| Project | IEEE 802.16 Broadband Wireless Access Working Group | |
| Title | UL Access Region Size Request for Semi-Distributed RS | |
| Date: | 2007-07-19 | |
| Abstract | This contribution proposes signaling to enable UL Access Region Size Request from an RS to an MR-BS with semi-decentralized scheduling. | |

Figure XXX – RS UL Size Request Header

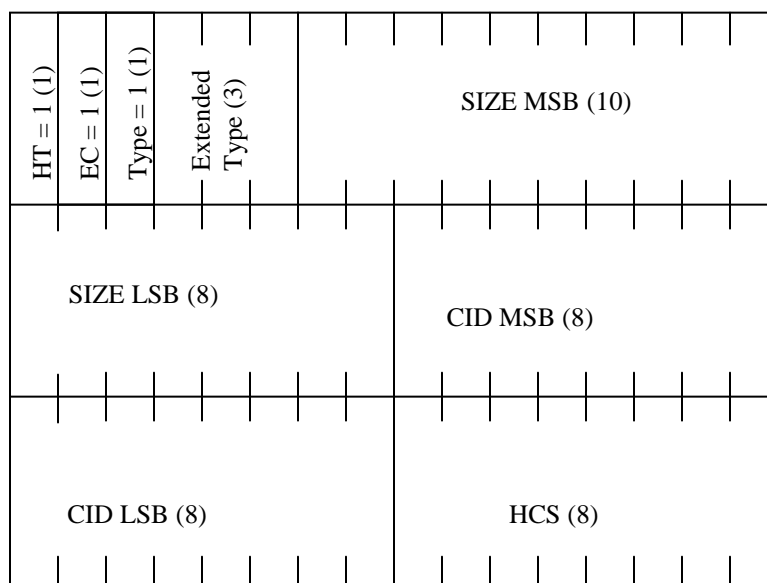
Under distributed scheduling, an RS may request size for its region of the access zone from the superordinate RS/MR-BS by sending the RS UL Size Request Header. The header specifies the requested size of the RS region of the uplink access zone in ODFMA slots. The header format is as follows:
